**LOWER TUOLUMNE RIVER FLOODPLAIN
HYDRAULIC ASSESSMENT
STUDY REPORT
DON PEDRO PROJECT**

FERC NO. 2299

Prepared by:
HDR, Inc.
and
Stillwater Sciences

February 2017

Figure 3.2-1. Flow exceedance at USGS Gage 11290000 Tuolumne River at Modesto CA, WY 1971 to 2012.

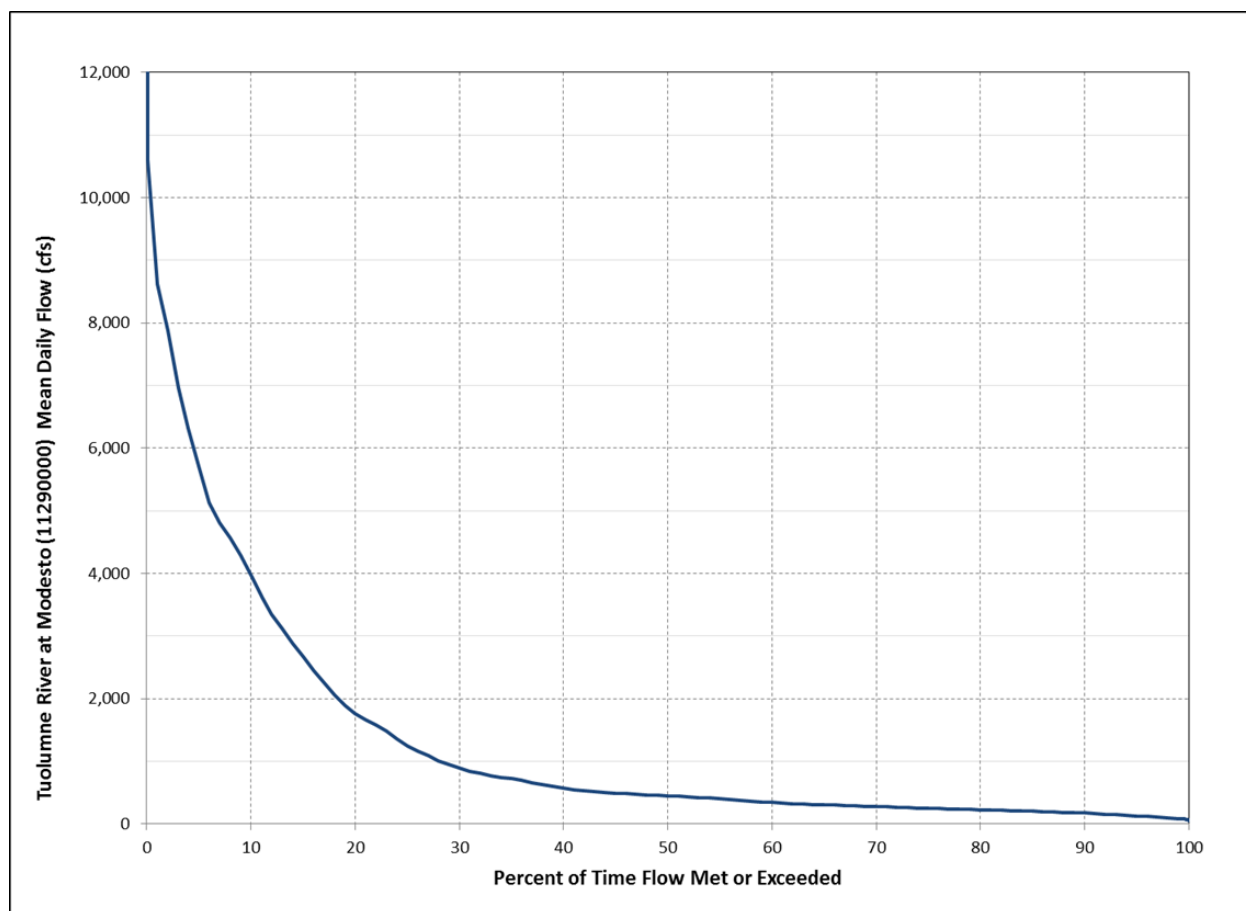
Figure 3.2-1 on page 3-4: This graph shows only flow exceedance from current operations. In order to interpret the effect of the Project on the floodplain, this graph should also present the flow-exceedance curve for unimpaired flows.

Figure 5.2-1. Total inundated floodplain area as a function of discharge within three modeled reaches of the lower Tuolumne River.

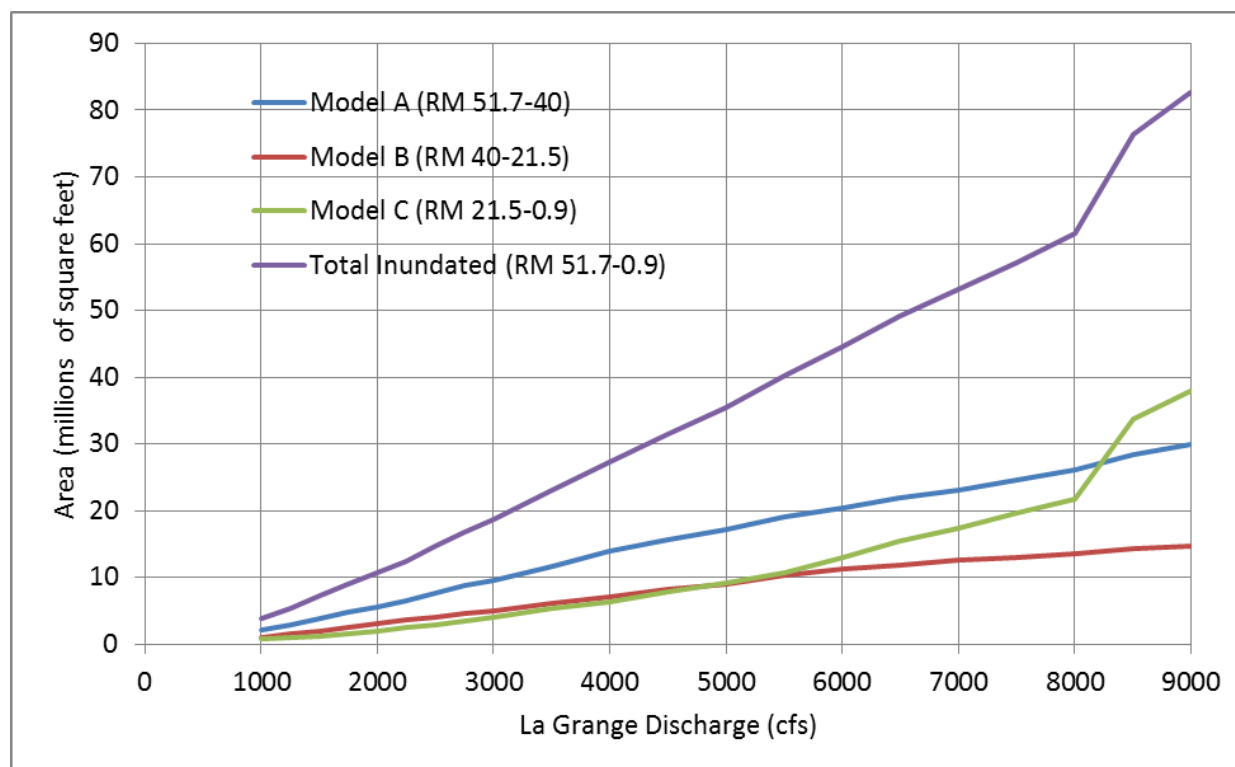
Page 5.2, Figure 5.2-1: We recommend that the Districts overlay the floodplain extent from the floodplain modeling with the empirical floodplain polygons used in U.S. Fish and Wildlife Service (2008), because the amount of floodplain area versus flow in U.S. Fish and Wildlife Service (2008) is generally more than the total in this report combining Models A, B and C. It would be expected that the combined floodplain area from this report, covering over 50 miles of the Tuolumne River, should be significantly more than the floodplain areas in U.S. Fish and Wildlife Service (2008), which only covered 30 miles of the Tuolumne River. We would have expected that the floodplain delineation from the two reports would be similar for the area in common, because the U.S. Fish and Wildlife Service (2008) assumed that floodplain inundation started at 1,100 cfs, and this report used the 1,070 cfs inundation extent to delineate overbank versus in-channel areas.

Figure 1. USFWS analysis of Draft Report data: Regression showing the relationship between percent survival of juvenile Chinook salmon in the Tuolumne River and the acre-days of floodplain inundation downstream of La Grange Dam.

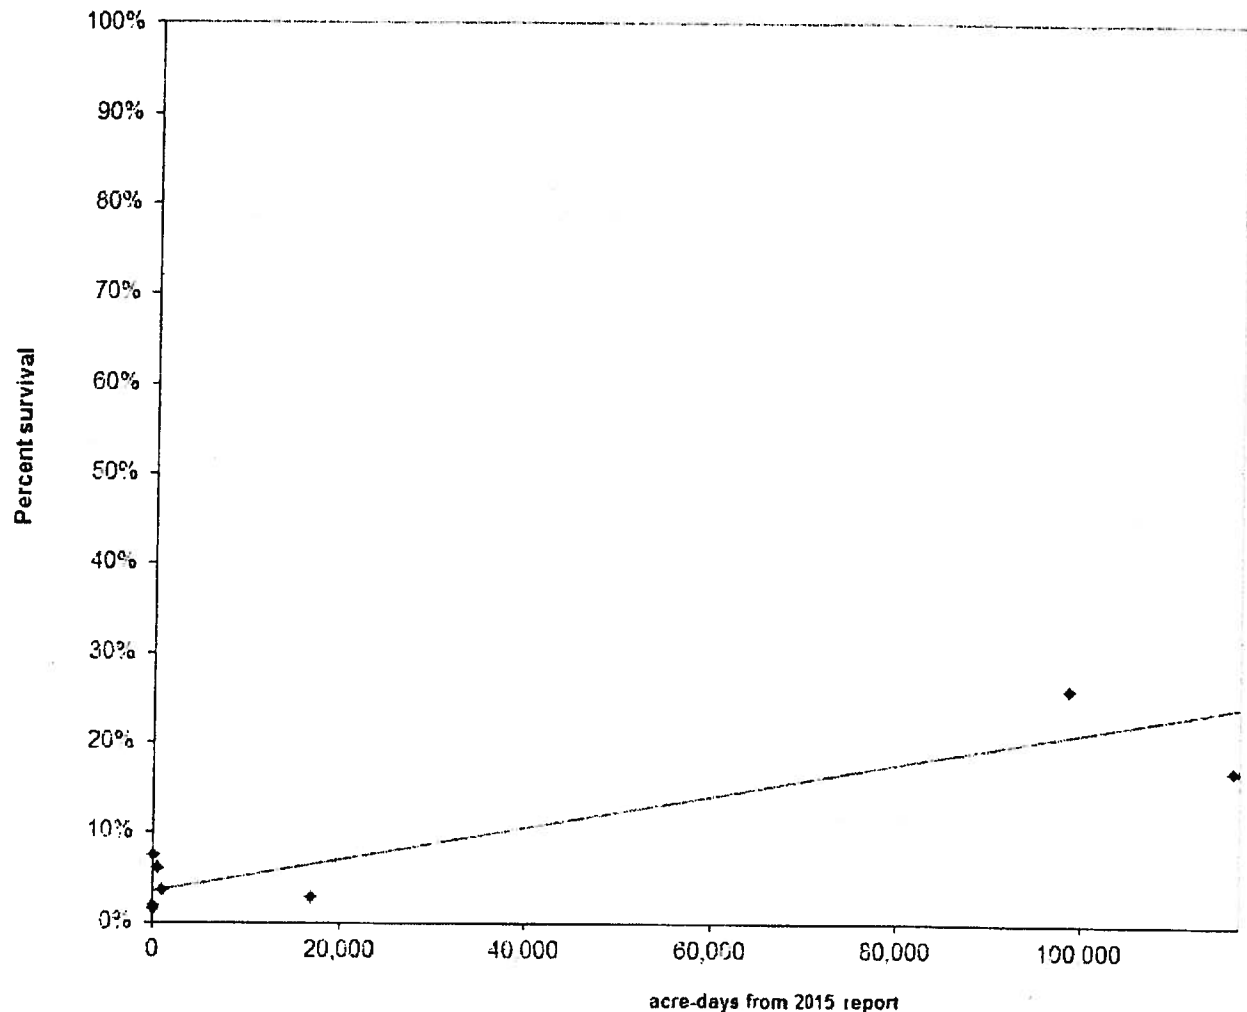
The resulting regression, as shown in Figure 1, will have an r^2 value of 0.79 and predicted percent survival ranging from 3.67% with no floodplain inundation to 27.49% with 150,000 acre-days of floodplain inundation. The relationship shown in Figure 1 could be used to develop PM&E measures, which could be achieved through a combination of higher flows and floodplain restoration projects which lower floodplain elevations. For example, using the survival goals in the Scientific Evaluation Process Group's 2014 report for the Stanislaus River, the PM&E measures would be 8,400 acre-days in dry years (to achieve 5% survival), 41,000 acre-days in normal years (to achieve 10.18% survival) and 71,350 acre-days in wet years (to achieve 15% survival).
